Response to the Reviewers' Comments

The authors would like to thank the reviewers for the precious comments and suggestions on the technical contents and presentation of our manuscript "Runtime Power Management of Battery Electric Vehicles for Extended Range with Consideration of Driving Time," submitted to IEEE Transactions on Very Large Scale Integration (TVLSI.) This revised manuscript has been greatly improved thanks to the reviewers' invaluable advices. We have revised the manuscript faithfully following the reviewers's comments. We include the newly added or significantly modified parts in the revised version of the paper also in Response to Reviewers. We highlight the important technical content changes and set those parts in a red color in the revised paper.

Fig. 2: (a) Range-speed experimental data for Chevrolet Bolt [36] and (b) comparison with simulation results of the proposed EV power model.

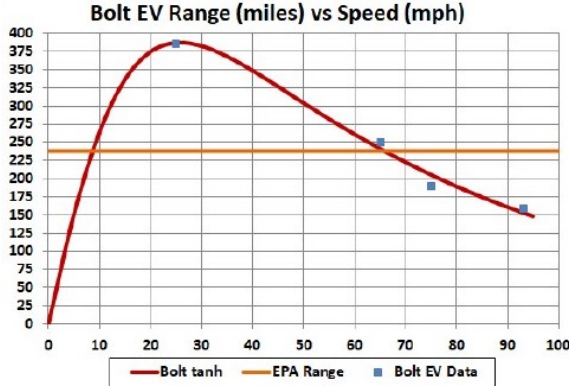
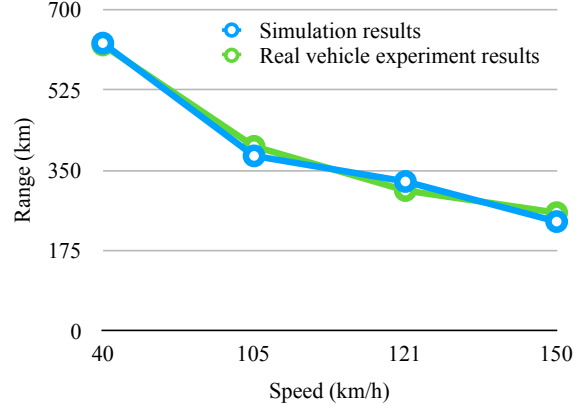
R1-C2 It is not clear how to validate the power model of EV. As the author mentions that accuracy of power model is quite important, it is good to see the power model in this paper can be validated by some real measurement results.

R2-C1 The paper claims that the proposed BEV power model is more accurate than those in the literature. While the results in Section V demonstrate the benefits of the proposed model and in some way indirectly show its accuracy, it would be good to have a direct comparison of model accuracy between the proposed model and those in literature, e.g., based on simulations as in Fig. 1.

We further evaluate the model accuracy with the range-speed real vehicle experiments as shown in Fig. 2(a) to confirm the derived power models are close enough to the real vehicle measurement data [32], [33], [34], [35], [36]. We refine the coefficients until all the available data values match well.

As a result, the derived EV power model well matches with the range-speed experimental data as shown in Fig. 2(b) as well as the top speed and maximum acceleration setting the aerodynamic resistance, rolling resistance, curb weight, etc. with the known values. The errors in the range-speed simulation is merely 1.4%, the time for 0-to-100 km/h error is 7.8%, and the top speed error is 3.0%, respectively.

Fig. 12: Velocity profile comparison with EDP , E^2DP and E^3DP on Serrano Avenue in Anaheim Hills.

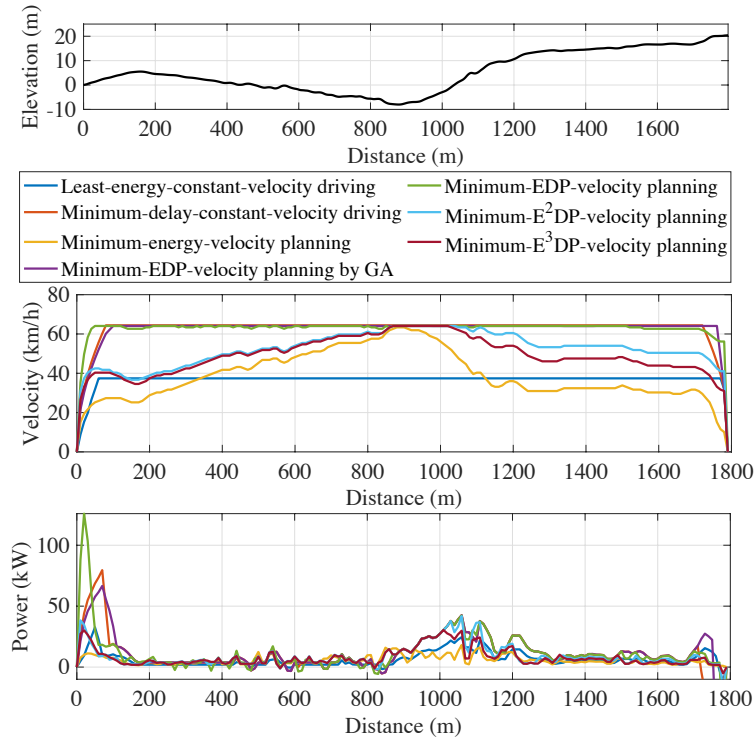
R1-C3 The optimality of the proposed scheduling algorithm is unclear. The author should add several paragraphs to discuss this topic. It is also to see the comparison baseline is well accepted to show the advantage of the proposed algorithm.

Fig. 12 summarizes EDP of the least-energy-constant-velocity driving, the minimum-delay-constant-velocity driving, the minimum-energy-velocity planning, the velocity planning with EDP , E^2DP and E^3DP as a metric on the road benchmarks and the minimum- EDP -velocity planning with GA. The proposed velocity planning results in up to 46.2% improvements of EDP compared with the least-energy-constant-velocity driving. The driving velocity on a flat road is faster than that of the least-energy-constant-velocity driving at the expense of relatively little energy to save driving time. Then, the velocity decreases when climbing the following uphill to spend less motor torque, which saves more energy.

In addition, EDP of the proposed EDP-aware-velocity planning is merely 4.3% higher than that of the true EDP-minimum-velocity planning on average. Through this results, we confirm that the results of the proposed heuristics are close enough to the true optimal solutions.

We also updated Fig. 12 and Fig. 13:

Fig. 11: Histograms of velocity and acceleration for the proposed energy-aware-velocity planning methods without an acceleration constraint (a) and (b) and with an acceleration constraint (c) and (d), respectively.

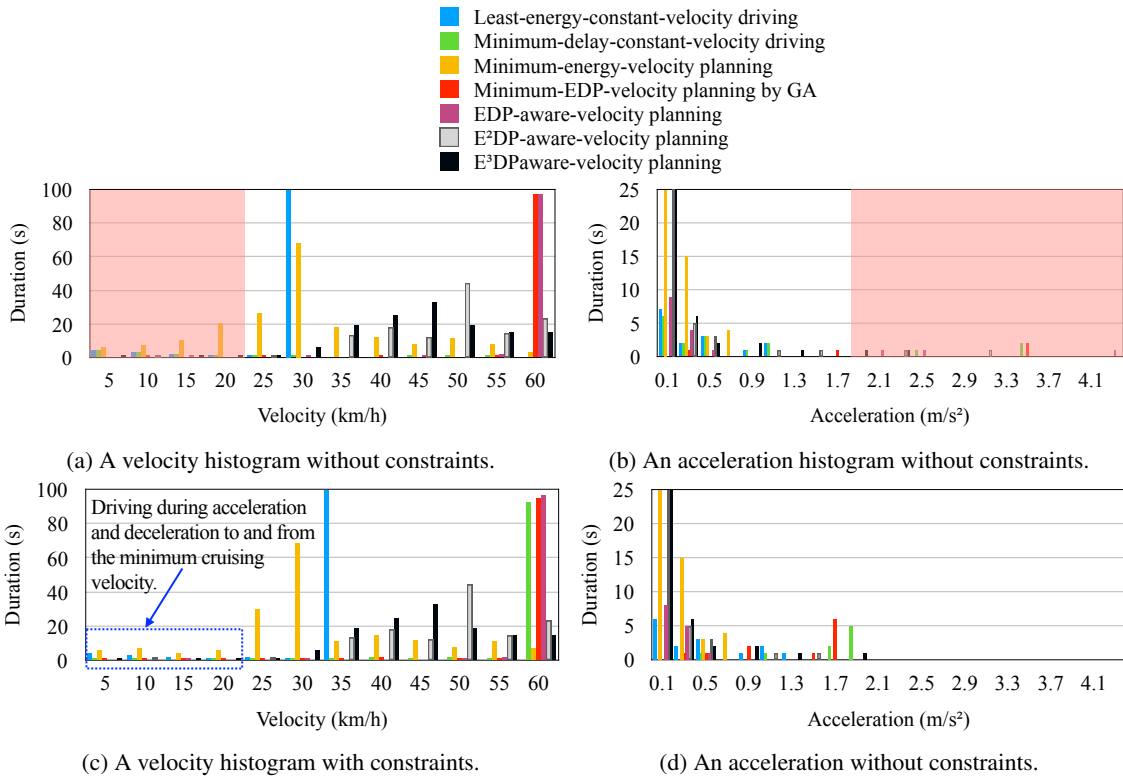
R2-C2 It would be good to have more discussion on the assumptions of the approach and the experiments, e.g., how much can the velocity be changed in practical scenarios without impeding traffic and causing unsafe situations (also depending on the road conditions and whether it is urban or rural environment I suppose). Currently, there only seems to be one constraint on not slower than 10 km/h.

Fig. 11(a) and (b) show two histograms of the driving schemes in Fig. 12, which do not have velocity and acceleration constraints. We avoid a cruising velocity lower than 25 km/h and an acceleration higher than 2.0 m/s^2 in this paper without loss of generality. The acceleration of 2.0 m/s^2 is the same as the maximum acceleration of compact cars designed to be used primarily used in urban areas (13 seconds of 0 to 100 km/h time).

Fig. 11(c) and (d) shows the velocity and acceleration histograms with the constraints. Once we run the DP for the first time without constraints, we analyze the histogram, adaptively determine the minimum cruising velocity and maximum acceleration constraints, and run DP again. We keep the same constraints for online recomputation whenever unexpected interrupts occurs.

We also enforce the minimum acceleration not lower than 1.0 m/s^2 when the EV starts from a stop sign or a traffic light until the velocity reaches to the minimum cruising velocity not to bother traffic flow. The acceleration of a 1.0 m/s^2 exhibits 6 second delay to reach 25 km/h. The maximum speed is bounded by the speed limit of each road benchmark.

Fig. 8: Altitude changes in the real road benchmarks.

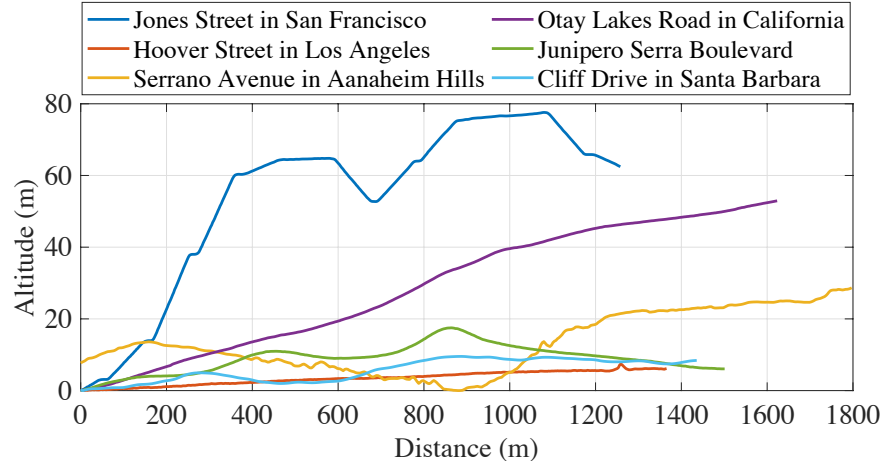
R2-C3 Related to the last point, it would be good to have more discussion on the road benchmarks, e.g., how they are generated and how representative they are. The optimization results significantly depend on road slope. It would be good to use a variety of real road segments for testing.

R2-A3 We appreciate the reviewer's comment. We replaced the previous synthetic road benchmarks with the real road benchmarks. We made six new real road benchmarks from various locations in California. The first three roads are in cities. Jones Street in San Francisco and Hoover Street in Los Angeles are two representative city landscapes such as hills and flat roads, respectively, and Cliff Drive in Santa Barbara is a mixture of those. The second two roads are in mountain areas: Serrano Avenue in Anaheim Hills and Otay Lakes Road in San Ysidro Mountain in California. The last road is Junipero Serra Boulevard connecting San Francisco and San Jose. The

details of road data is summarized in Table II, and Fig. 8, which visualize the altitudes of the road benchmarks. We also revised all the associated contents with the new real road benchmarks.
